**RE: AMENDMENT 2 - PETITION TO AMEND PROJECT BRIDGE WATER SUPPLY
(02-AFC-4C)**

**WALNUT ENERGY CENTER
(02-AFC-4C)**

AMENDMENT NO. 2
(Alternative Water “Bridge” Supply)

Submitted by
Walnut Energy Center Authority

FIGURE 1
GROUNDWATER WELL EXCLUSION AREA
WALNUT ENERGY CENTER
CH2MHILL

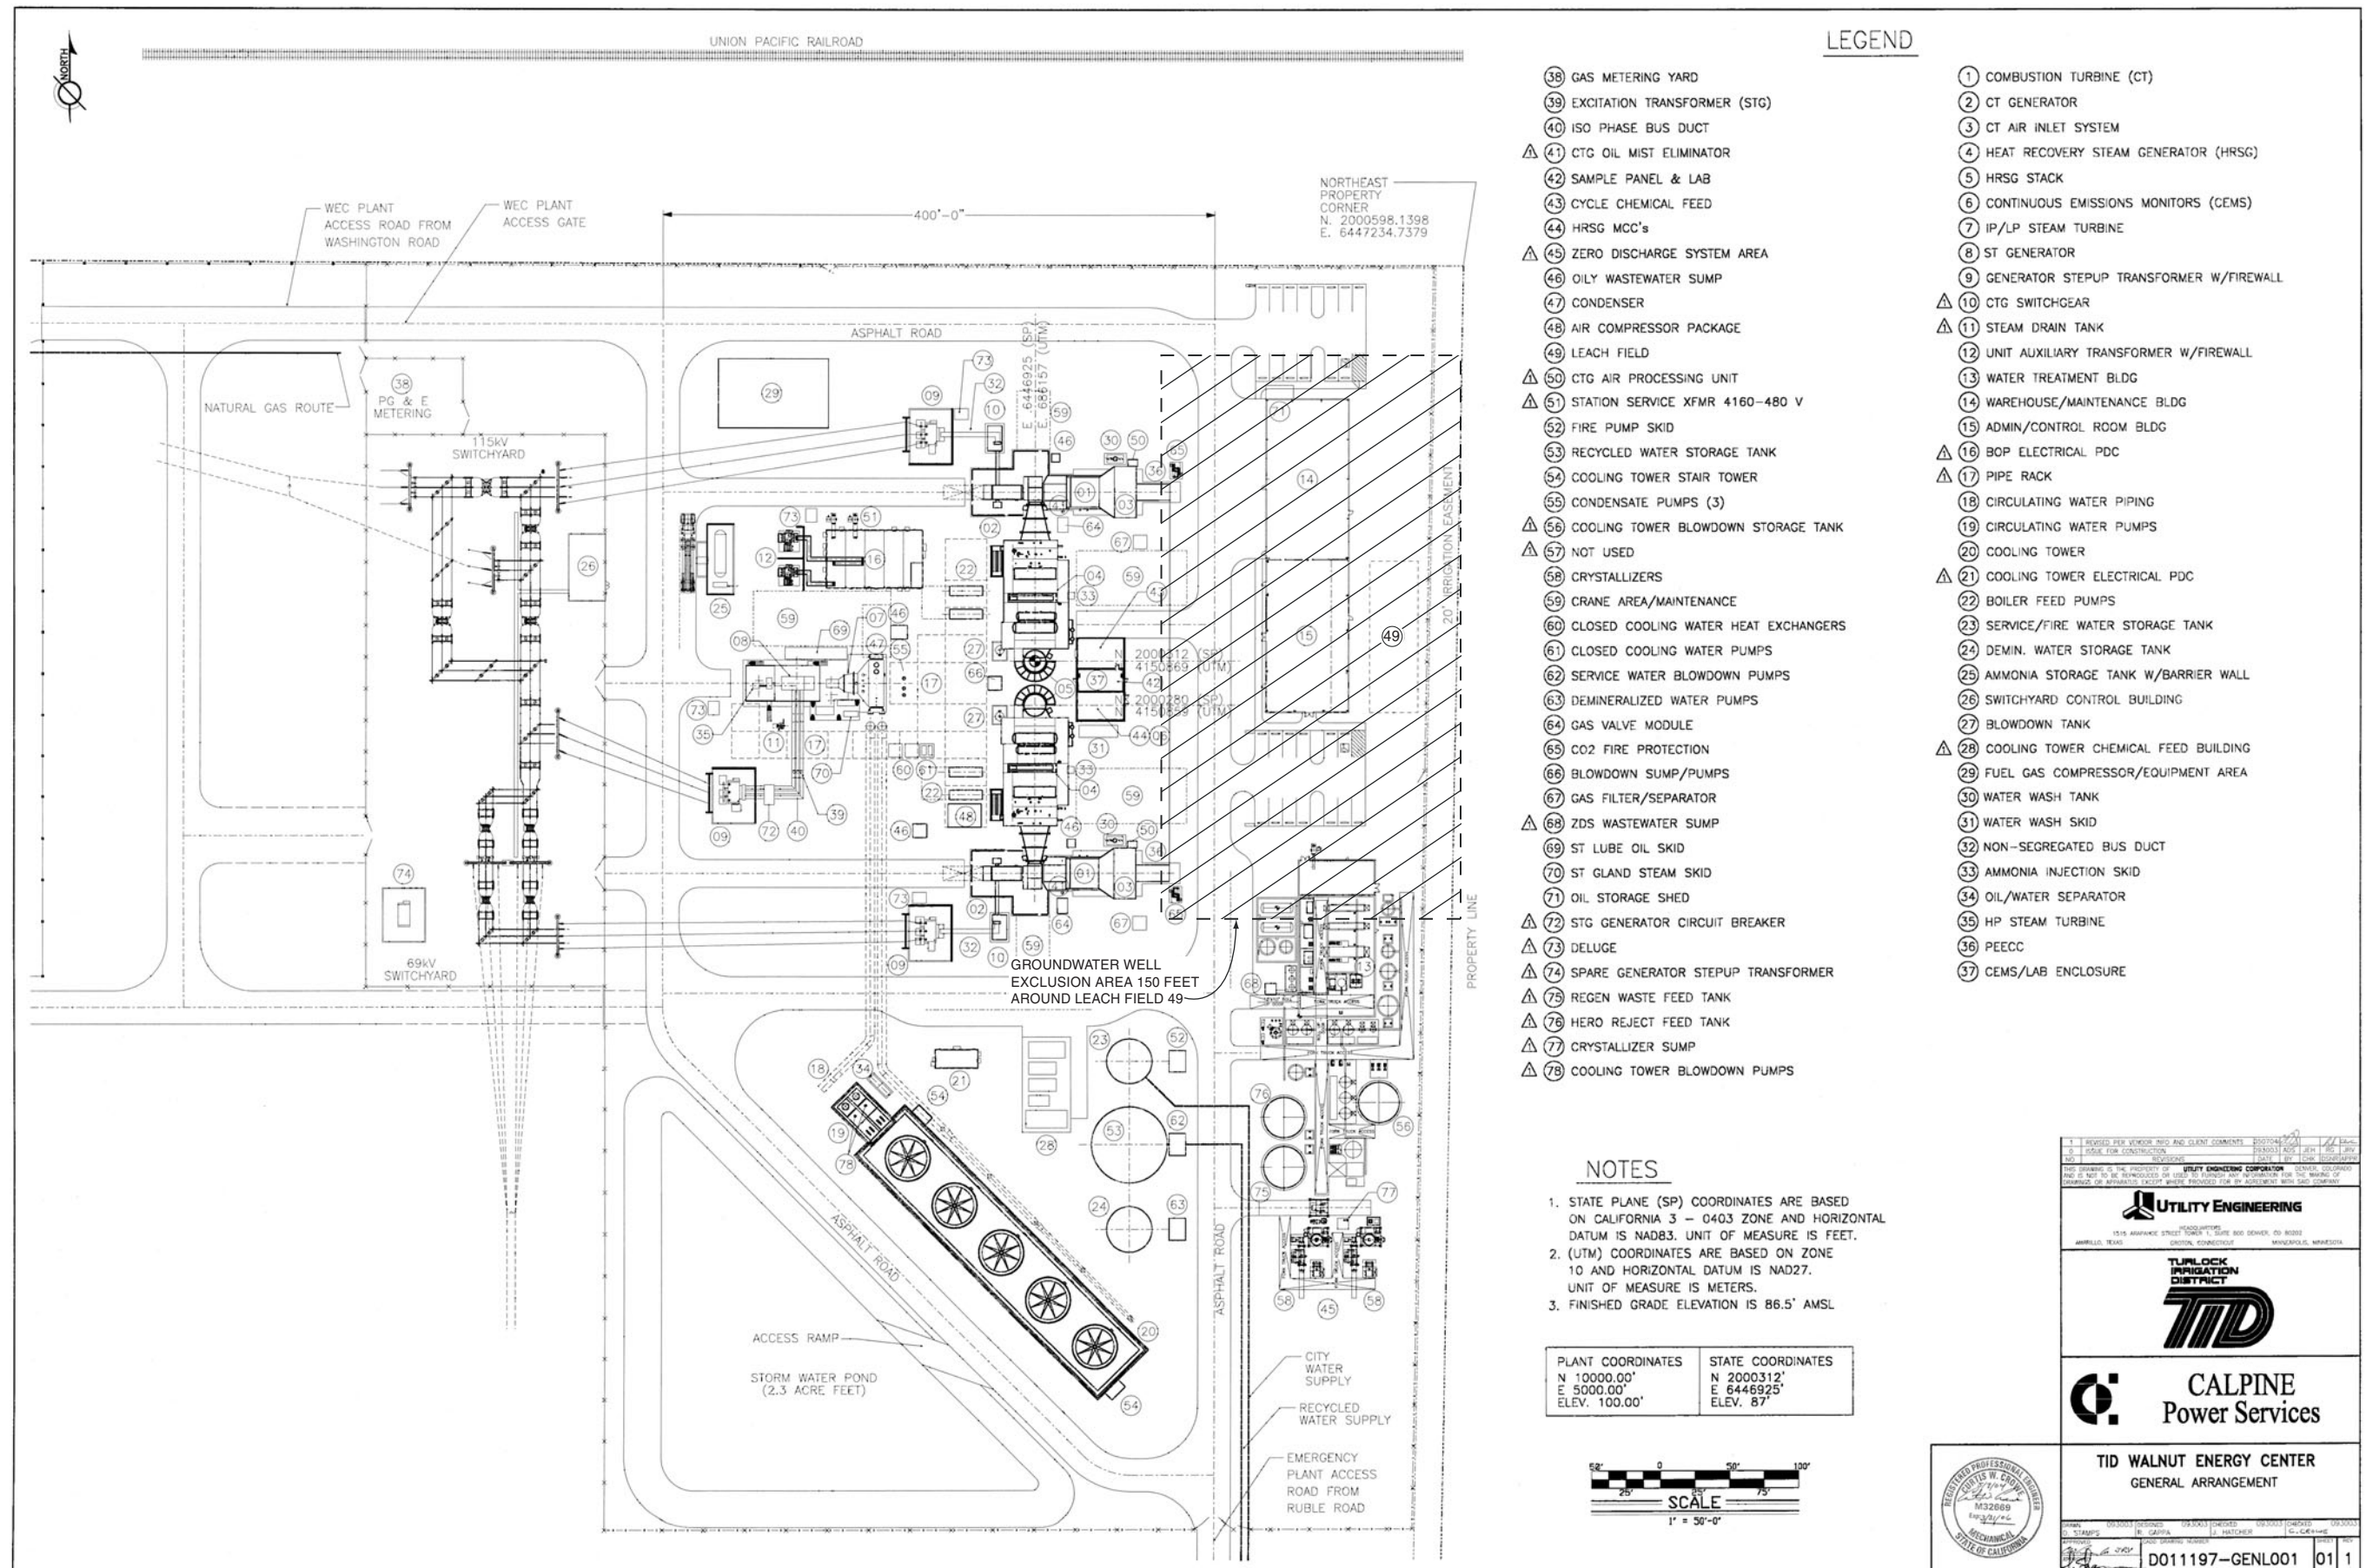
Pipelines would be installed to transport water to the non-potable cooling tower makeup line located at the east side of the project site. As shown on Figure 1 (all figures are located at the end of the document) the wells on the WEC project site would be located anywhere within the 18-acre site, except within 150 feet of the leach field. This area around the leach field is shown in the figure as an exclusion area to comply with Department of Health Services and Stanislaus County requirements for horizontal separation from the leach field. If the Authority chooses to develop the wells at the South Washington location (see Figure 2), an 8- to 14-inch water pipeline within already developed roads and rights-of-way would transport the water from the South Washington wells to the WEC project site. From the South Washington wells, the pipeline route would extend east paralleling the UPRR railroad tracks, located on the south side of the District's South Washington Road equipment Storage Area. At South Washington Road, the horizontal directional drill construction method would be used to cross under both the railroad tracks and South Washington Road. Once the pipeline is on the east side of South Washington Road, it would turn south, paralleling the road until it reaches the access road to the WEC project site. The pipeline route would turn east, running parallel to or within the access road until it reaches the WEC project site.
